VALERO IMPROVEMENT PROJECT

Addendum to VIP EIR

Prepared for
City of Benicia

June 2008

Figure 3-11
Fluid Coker Process

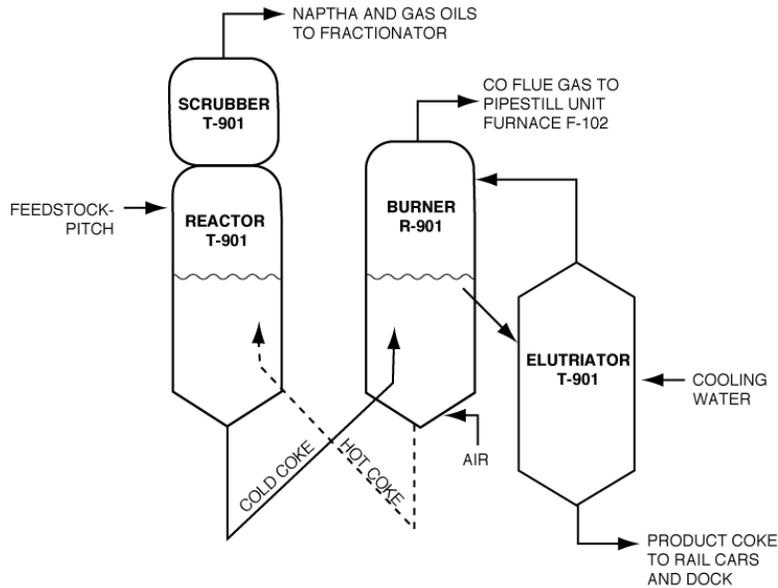
Valero plans to install a new SO₂ scrubber to treat the combined exhausts of the FCCU and the Coker (see section 3.4.3. FCCU Feed Flexibility and section 3.4.3.5 New FCCU/CKR Scrubber).

Figure 3-14
Flue Gas Scrubber Process

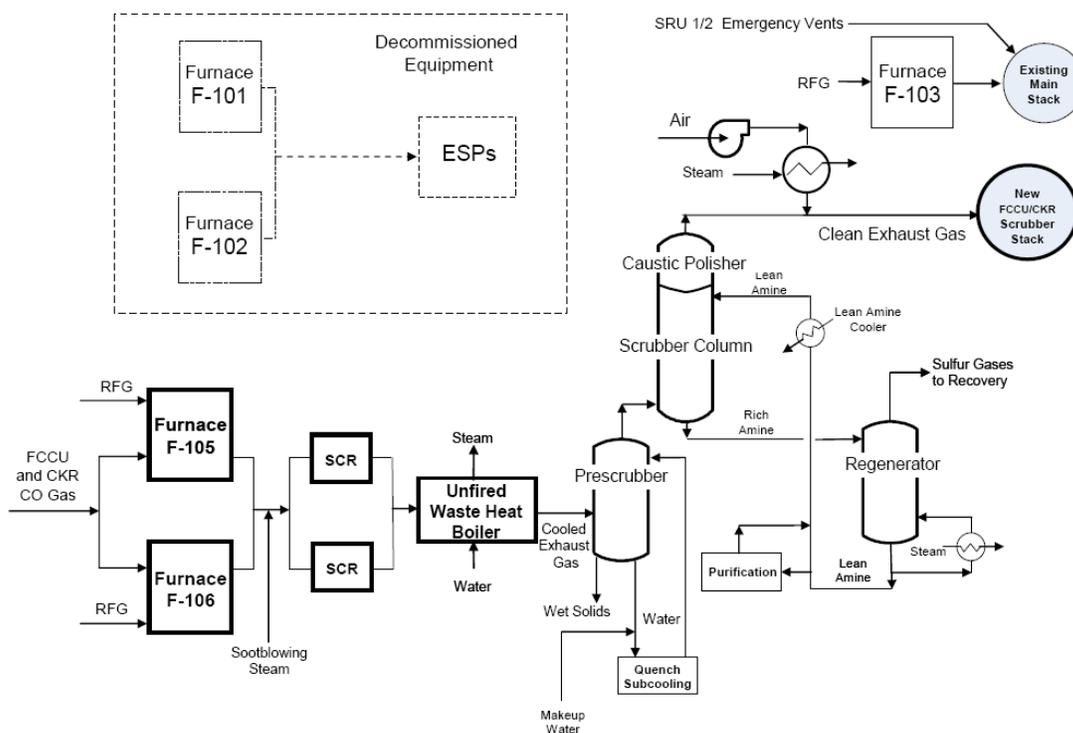
In the case of the proposed ~~Main Stack~~ FCCU/CKR Scrubber, a chemical solution would absorb the **SO₂** produced when refinery gas is burned. **Valero plans to install two new combustion furnaces, F-105 and F-106, which can operate at the higher pressures required for the scrubber operation than the existing furnaces F-101 and F-102. These new furnaces will have SCR to remove NO_x generated in the FCCU and CKR and from combustion in the furnaces.** To optimize

The Scrubber would use a regenerative amine process. To maintain effectiveness of the amine solution, Valero is planning on adding a prescrubber to remove catalyst fines carry over from the FCCU and ash and coke fines carry over from the Coker. The particulate control provided by the prescrubber will eliminate the need to operate the existing electrostatic precipitators (ESPs), which will be decommissioned.

The prescrubber will include quench subcooling to further lower the temperature of the gases entering the scrubber. The circulating pre-scrubber water will pass through a heat exchanger where it will transfer heat to a cooling medium, such as a glycol/water mixture. Air-fin coolers are then used to reduce the temperature of the glycol/water mixture.
